Technical Service Bulletin: TSB170102

Belt Shredding: Charging System Alternator Out of Alignment

Figure 1, Charging System Alternator Mounting Torque Sequence.

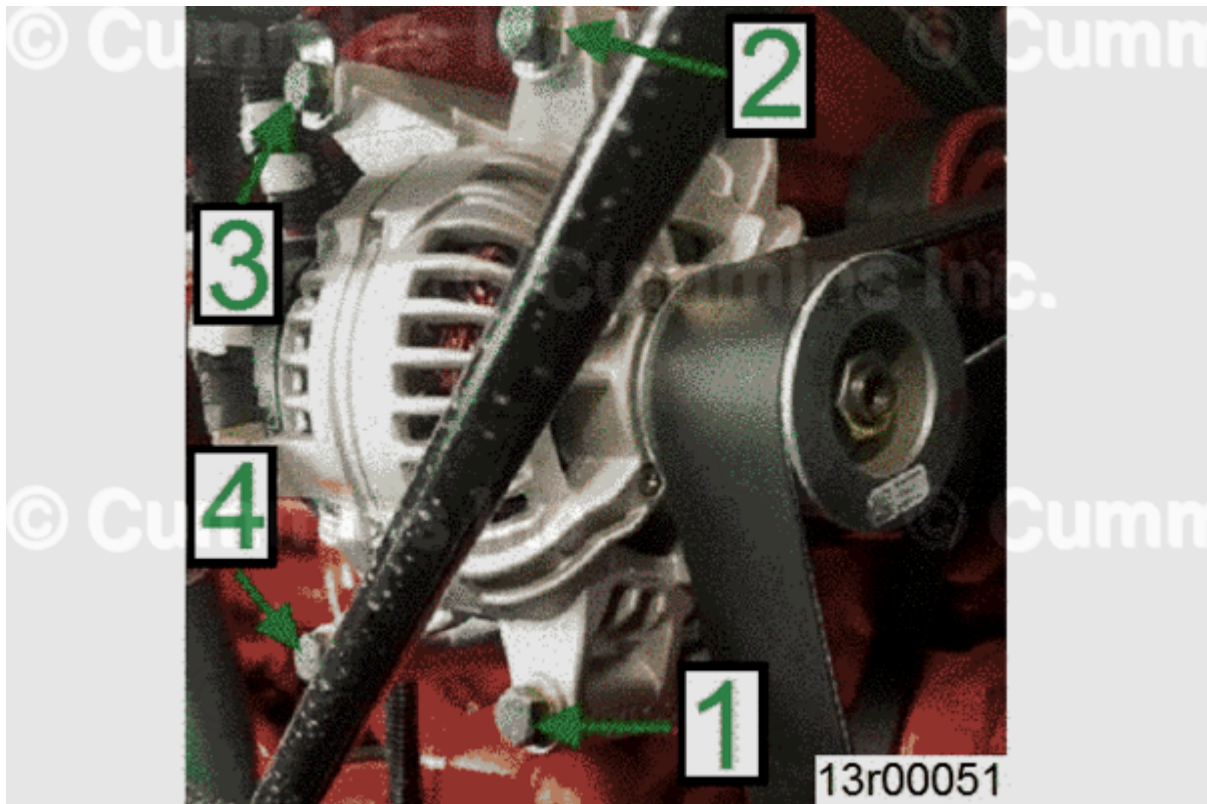
- Belt shredding beginning on inside rib (closest to cab of truck)

- Charging system alternator is **not** properly aligned

- If charging system alternator is **not** properly aligned, four charging system alternator mounting capscrews **must** be loosened and torqued starting with bottom right capscrew and continuing **counterclockwise**.
 - See Figure 1 below for charging system alternator capscrew torquing sequence.
 - For charging system alternator capscrew torque specifications, see corresponding Service Manual. Reference Procedure 013-001 in Section 13.
- After following charging system alternator capscrew tightening sequence outline above, use laser alignment tool to confirm charging system alternator is properly aligned.
